**HINCKLEY NATIONAL  
RAIL FREIGHT INTERCHANGE**

Project reference TR050007

**Appendix 12 - M69 J2 Modelling Note**

<b>PROJECT NAME</b>	<b>Hinckley National Rail Freight Interchange</b>		
<b>DOCUMENT NUMBER</b>	HNRFI-BWB-GEN-XX-RP-TR-0044	<b>BWB REF</b>	NTT2814
<b>AUTHOR</b>	Vibeeshan Devaharan	<b>STATUS</b>	S2
<b>CHECKED</b>	Malcolm Ash	<b>REVISION</b>	P03
<b>APPROVED</b>	Shirley Dumigan	<b>DATE</b>	11/11/2024

Drawing Title  
**HIGHWAY PLANS SHEET 4 OF 8**

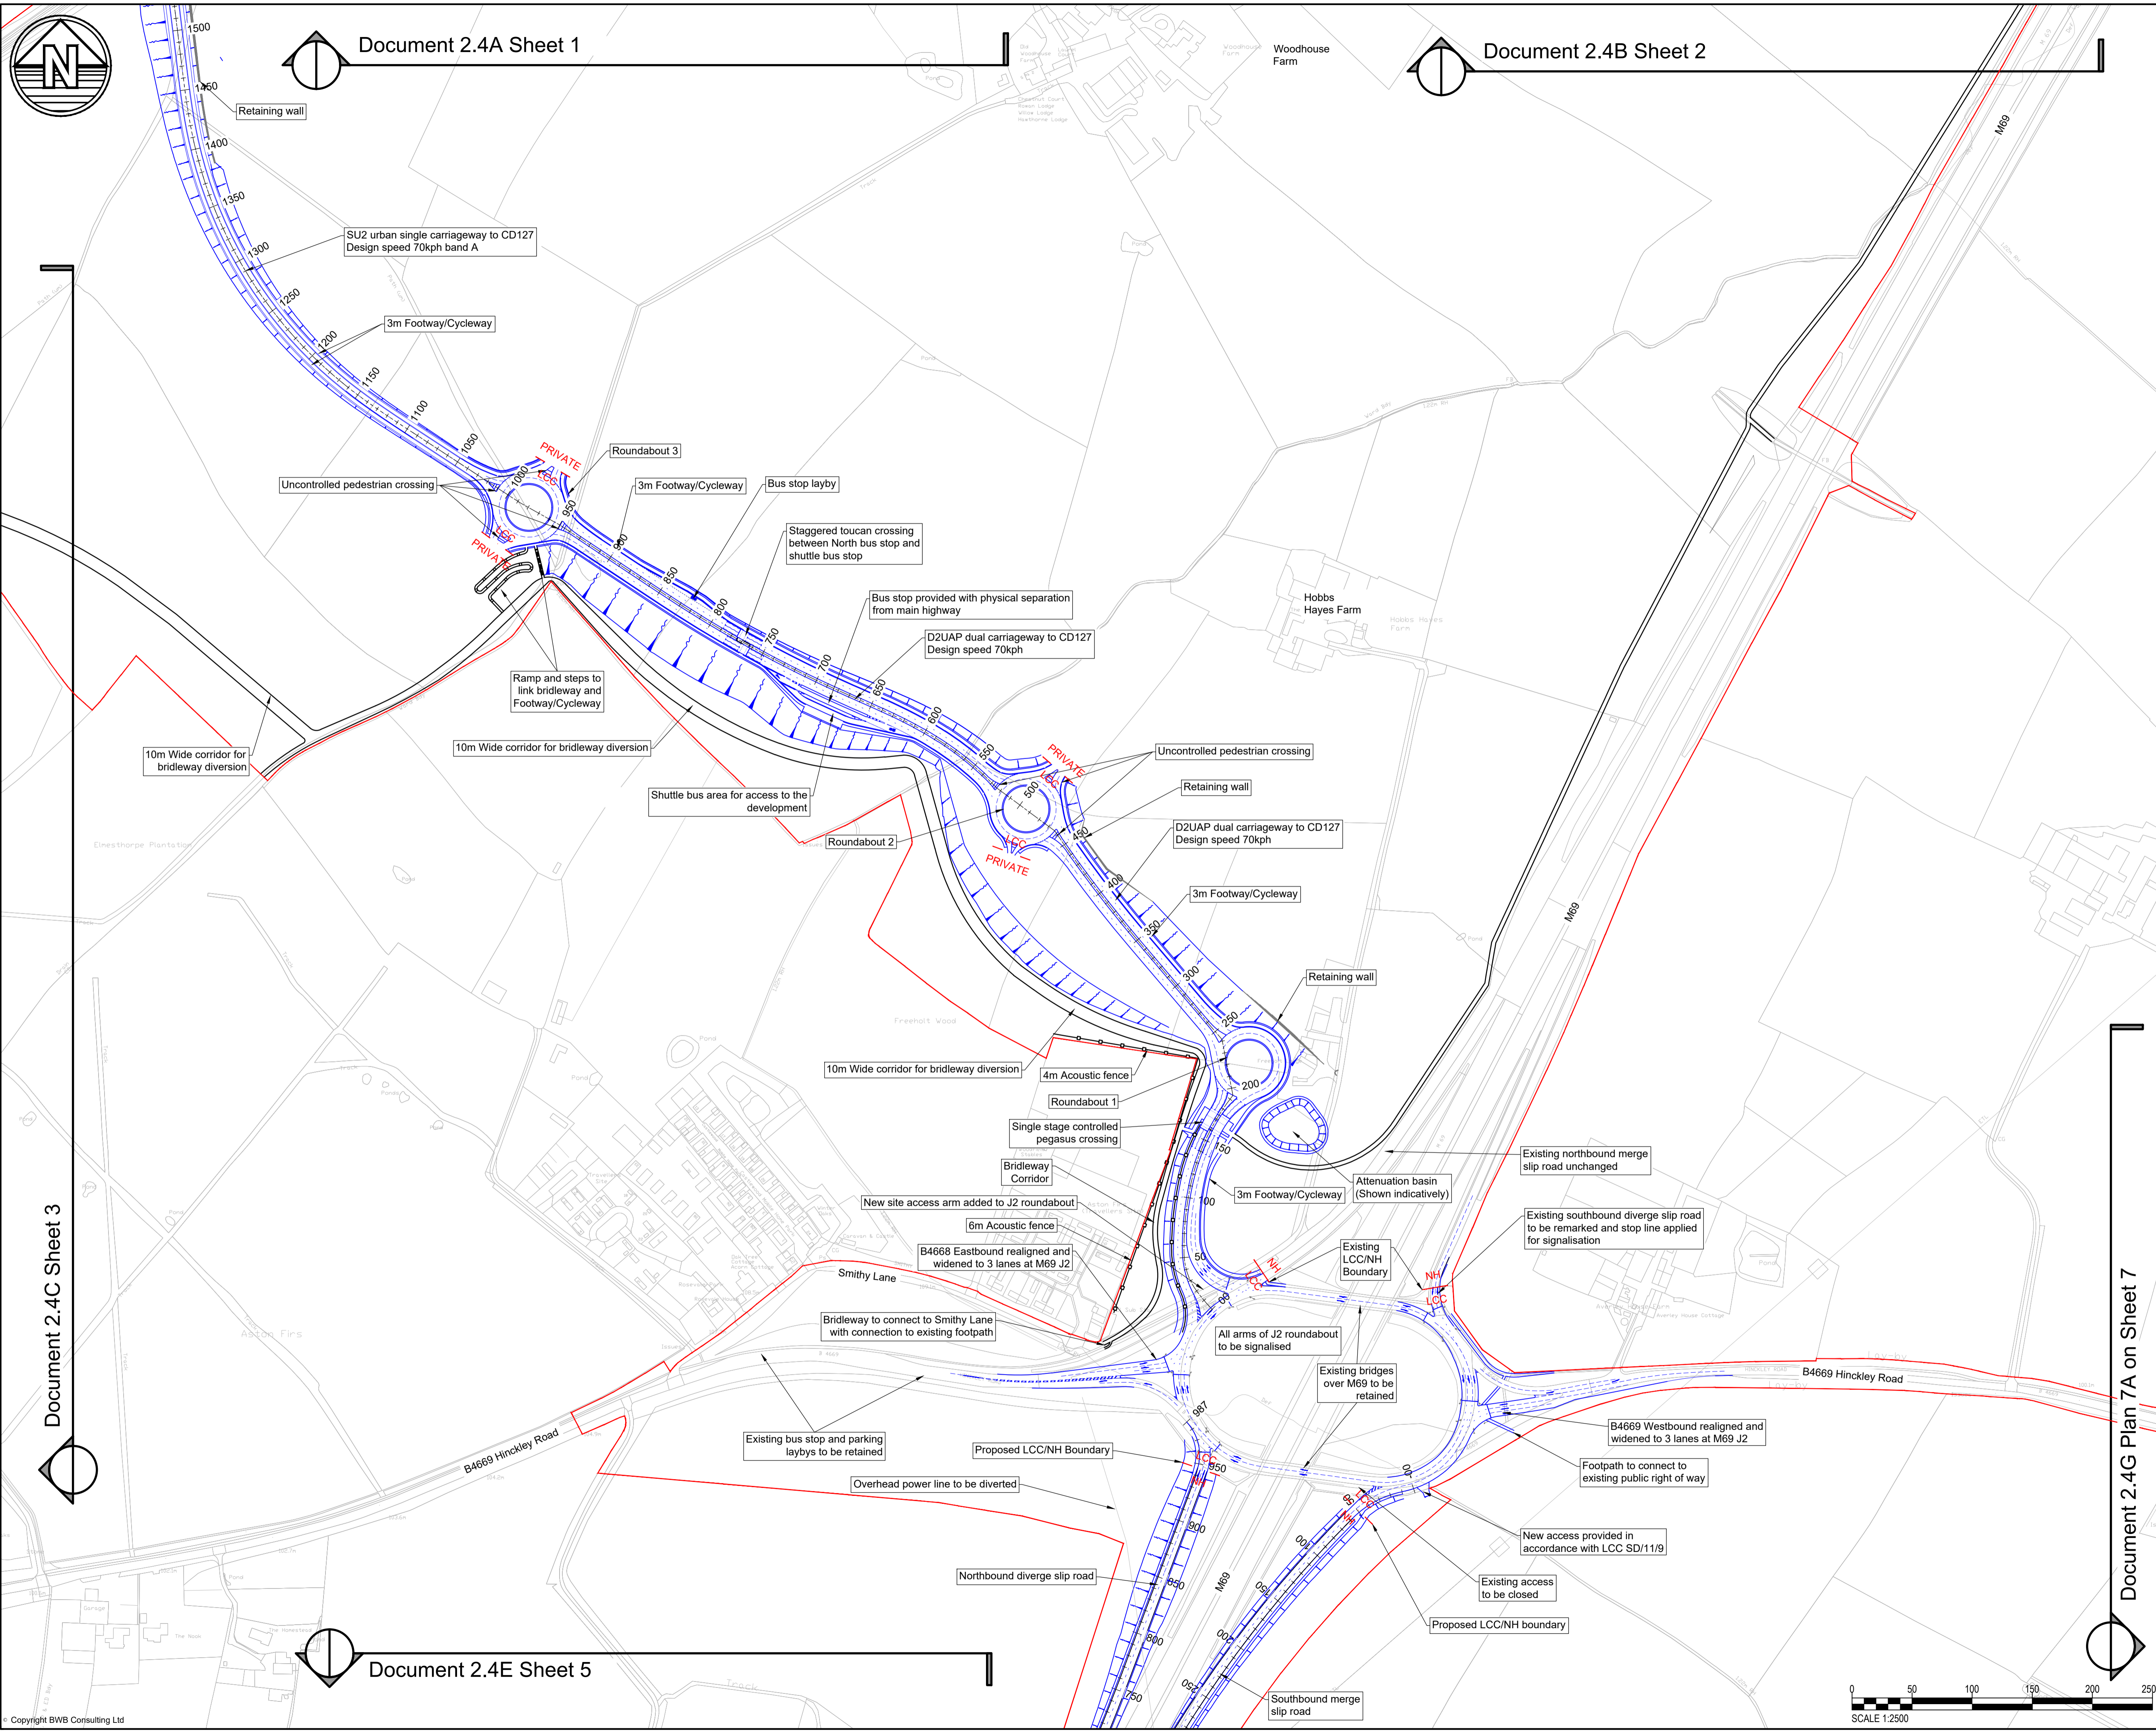
3.2 Furthermore, due to the requirement for an acoustic barrier west of the proposed A47 link road roundabout, the A47 link was moved approximately 7m to the west. However, it should be noted that this does not affect the number of lanes or stacking capacity provided. NH's consultants confirmed and agreed that this would not have any material

impact on the VISSIM modelling. A comparison of the original A47 link alignment (black) and new alignment (magenta) is shown in Figure 1.

- 4.1 LCC requested the rerun of the VISSIM model inclusive of the Pegasus crossing west of M69 J2. To provide a worst-case assessment, this has been modelled as a fixed time signal with the Pegasus crossing along the A47 link road called once every minute. An intergreen of 17 seconds has been accounted between crossing phase and traffic phase which accommodates a typical horse walking speed.
- 4.2 A copy of the drawing has been provided in **Appendix 1**.

- 4.3 A comparison of the network performance has been presented in **Table 2** and **3**.
